Nebraska Public Power District

NLS990126
January 1, 2000

Subject: Request for Enforcement Discretion and Supplement to Proposed License Amendment Request
Cooper Nuclear Station, NRC Docket 50-298, DPR-46

REQUEST FOR ENFORCEMENT DISCRETION FROM THE REQUIREMENTS
OF CNS TECHNICAL SPECIFICATION 3.7.3

Figure 1, Rev. 11

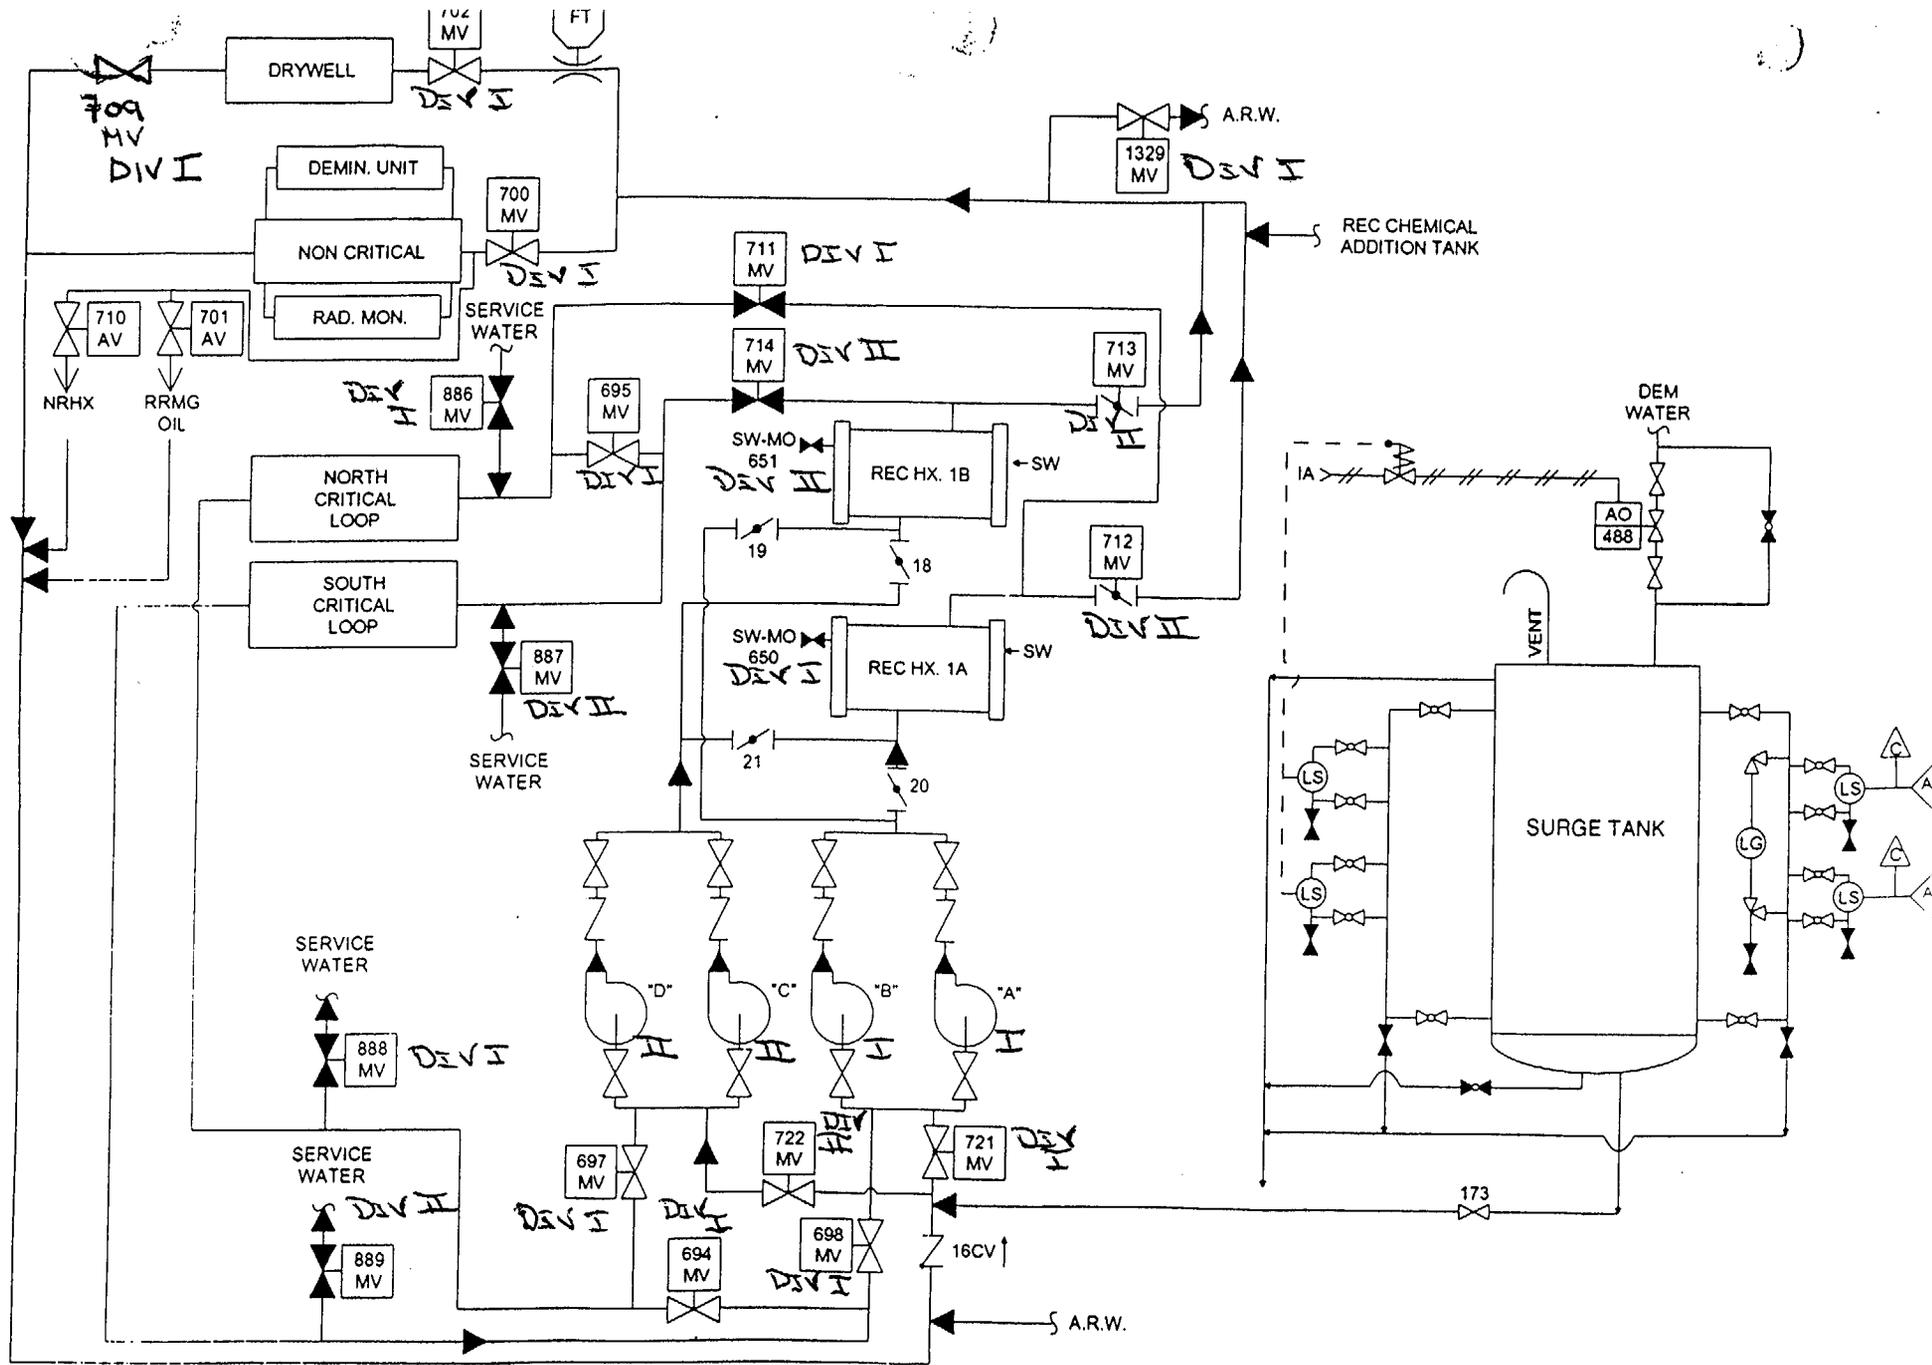
In a teleconference between J. Sumpter, et. al., (NPPD) and L. Burkhart, et. al., (NRC) on November 9, 1999, the NRC identified a postulated single failure vulnerability associated with the Amendment request contained in NLS99050. In a teleconference between NRC and NPPD personnel on January 1, 2000 additional questions were raised. This attachment provides the responses to the NRC questions raised in these teleconferences. Figure 1 provides an updated simplified diagram of the Reactor Equipment Cooling System. This figure includes annotation of the divisional power supply for each pertinent valve.

In a teleconference between J. Sumpter, et. al., (NPPD) and L. Burkhart, et. al., (NRC) on November 9, 1999, the NRC identified a postulated single failure vulnerability associated with the Amendment request contained in NLS99050. This single failure vulnerability involved the potential to divert the Service Water backup flow away from the Reactor Equipment Cooling critical loops via the non-critical drywell loop and a resultant flow being established through the surge tank vent. The District has completed an evaluation of this scenario and concluded that the postulated event can be accommodated by the existing REC system design. The supply valves to the drywell non-critical header, and two other non-critical headers (REC-MOV-700MV, -702MV, and -1329MV) are supplied motive and control power from Division I. The discharge valves from the heat exchangers (REC-MOV-712MV and -713MV) are supplied motive and control power from Division II. With isolation valves from both Division I and Division II in the flow path to the non-critical headers, there is no credible single failure which could prevent the isolation of the non-critical headers. The District acknowledges that the Figure provided in the original Amendment Request would have led the NRC to ask about this particular single failure.

The REC cross-connect valves (REC-MOV-694MV and REC-MOV-695MV) are maintained in the open position during normal operation. If either one of these valves is closed, the entire REC system is declared inoperable. See paragraph 6.5.1 of USAR Chapter X, Section 6.0, "Reactor Equipment Cooling System."

A question was asked relative to the impact of the non-critical loop header isolation valves leak-tightness on the operability of the REC System if a leak develops in the non-critical header. Specifically, how can the required seven-day inventory in the Surge Tank be guaranteed if we do not have a leak free seal in the non-critical loop header isolation valves.

Low pressure in the common discharge header signals an alarm in the main control room and automatically closes the Division I motor-operated valves in the supply headers to the non-safety-related-services. This action is initiated by a pressure switch which will send a signal to close MO-700MV, MO-702MV, and MO-1329MV when low pressure is sensed.

nonessential services. This action is initiated by a pressure switch in each heat exchanger's outlet which will send a signal to close MO-712MV if a low pressure condition is sensed in the 'A' heat exchanger outlet, and MO-713MV if a low pressure condition is sensed in the 'B' heat exchanger outlet.

Presently, REC system operability is determined based on total system leakage. There is no distinction between leakage rates in the critical or non-critical headers. Once total system leakage reaches a rate that indicates the system cannot operate for a minimum of seven days without make up water, the actions of TS LCO 3.7.3 will be performed. Since the operability of the system is determined on total system leakage, the position of the non-critical header isolation valves have no impact on ensuring the required seven day inventory is maintained in the surge tank.

The non-critical header isolation valves are required to isolate a potential flow path to the REC Surge Tank (which is vented to the Reactor Building atmosphere) during the Large Break LOCA scenario if the SW system back-up is required to be initiated following postulated equipment failures. A small leakage rate through these valves has no impact on the ability of the REC System to supply 7 days of cooling water without inventory makeup or the ability of the SW system to provide the required cooling flow through the REC critical headers.
